AMENDMENT OF SOLICITATION/MODIFICATION OF CONTRACT		1. CONTRACT ID CODE	PAGE OF PAGES 1 22
2. AMENDMENT/MODIFICATION NO. 000001	3. EFFECTIVE DATE 06/27/2013	4. REQUISITION/PURCHASE REQ. NO.	5. PROJECT NO. (If applicable)
6. ISSUED BY NASA/Marshall Space Flight Center Office of Procurement Marshall Space Flight Center AL 35812	CODE MSFC	7. ADMINISTERED BY (If other than Item 6) NASA/Marshall Space Flight Center Marshall Space Flight Center AL 35812	CODE MSFC
8. NAME AND ADDRESS OF CONTRACTOR (No., street, county, State and ZIP Code)		(x) 9A. AMENDMENT OF SOLICITATION NO. NNM13ZPS003E	
		X 9B. DATED (SEE ITEM 11) 05/29/2013	
		10A. MODIFICATION OF CONTRACT/ORDER NO.	
		10B. DATED (SEE ITEM 13)	
CODE	FACILITY CODE

The purpose of this amendment to IFB NNM13ZPS003E, Revitalization of Building 4666, is to provide answers to questions asked by several of the potential bidders. These questions and answers are being provided to assist all contractors in preparing their bid.

IFB NNM13ZPS003E, Amendment 1
Drawing for Question 1

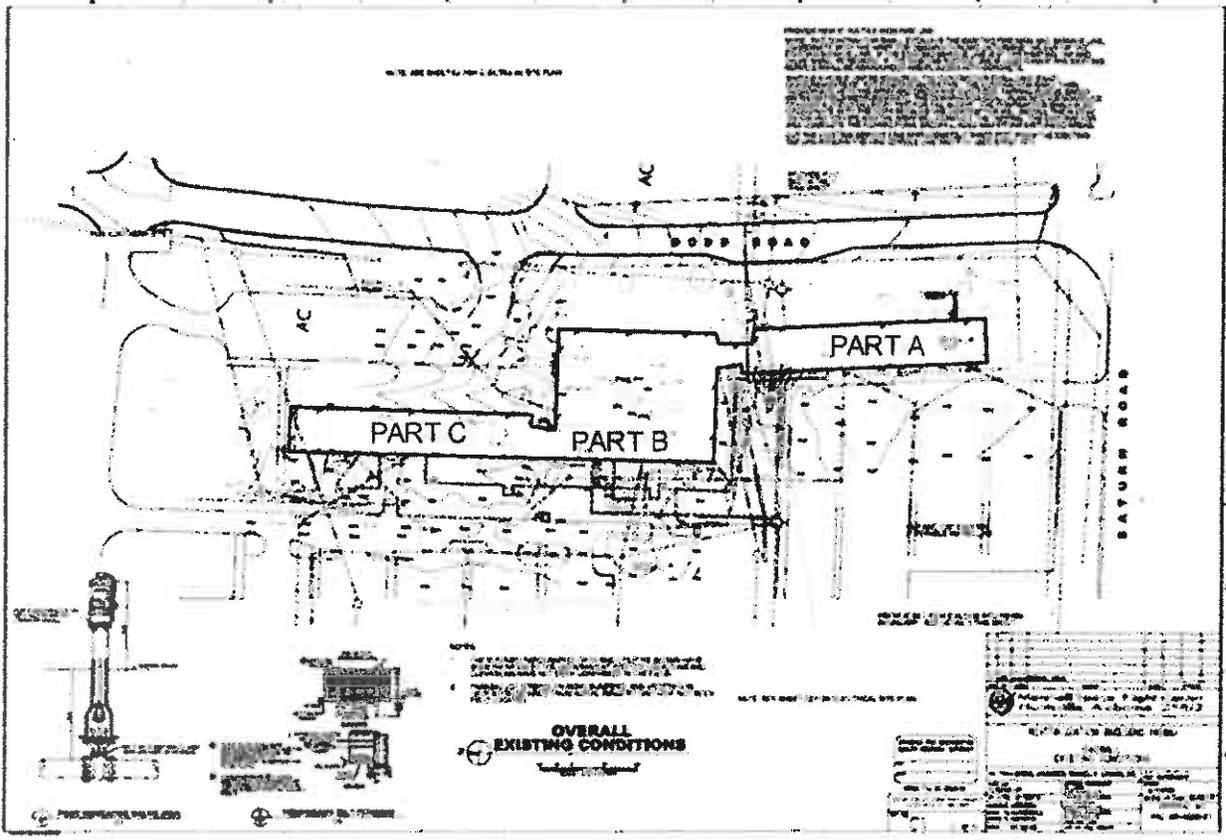
Question 1: It appears we are missing some civil drawings. On the civil drawing included in the package at the very bottom it says sheet 1 of 9, but the rest of the civil drawings are not provided and are not listed on the index. Was this a misprint or are there other drawings that we may possibly be missing?

Answer: Sheets C2-C9 were omitted from the package. No civil work north of "Part A" (South Wing) is allowed currently (no digging). The drawings were set aside in case the Army Continued ...

ITEM NO. (A)	SUPPLIES/SERVICES (B)	QUANTITY (C)	UNIT (D)	UNIT PRICE (E)	AMOUNT (F)
	<p>changes their position. The Drawing package is complete. "Part C" and "Part B" of 4666 sit in what is referred to as Marshall 3. Marshall 3 is a large area that is suspect for old Army munitions and is currently being investigated. The contractor will still be responsible for repairing all grassy areas disturbed during construction as explained in the specifications. See attached Drawing for Question 1.</p> <p>Question 2: Sheet E-2 has note for new underground secondary to consist of 6-4" conduits encased in concrete. Sheet E-30 has note for new underground secondary to consist of 8 sets of 4-350 mcm in 4" conduit. Please advise as to the number of conduits to be placed in ductbank and conductor size.</p> <p>Answer: Change note on E-2 to read 8 sets of 4-350 mcm in 4" conduit.</p> <p>Question 3: Drawing E-2 Shows duck bank to cable bus transition cabinet at 1st floor Part "A." 1st Floor "A" drawing E9/A7 shows running cable bus vertical and then horizontal to section "B" on exterior of building. On vertical run are we to core drill or "saw cut" concrete canopy as identified per drawing A-7 key note "B." This canopy is also identified on drawing A-30 detail 4. Is cable tray to be installed on top of concrete canopy? Will canopy support the specified cable bus? Is cable bus to be installed on exterior wall? Will exterior wall support cable bus? Please advise on routing of cable bus.</p> <p>Answer: Saw-cut the concrete canopy to accommodate the cable bus at two locations (cable bus duct is rectangular in shape). Refer to attached sketch of saw-cut opening in existing canopies. Final opening dimension will depend on cable bus provided by contractor. Verify final saw-cut dimensions and locations prior to work. The Cable Bus Duct (Assembly) is to be routed above the canopy (not attached/on it). Where notes on E2 for the cable bus duct refer to "platform," it is in reference to the "canopy." (i.e. "Route cable bus duct 1 foot above platform"...would be "Route cable bus duct 1 foot above canopy..."). The louver in reference for</p> <p>Continued ...</p>
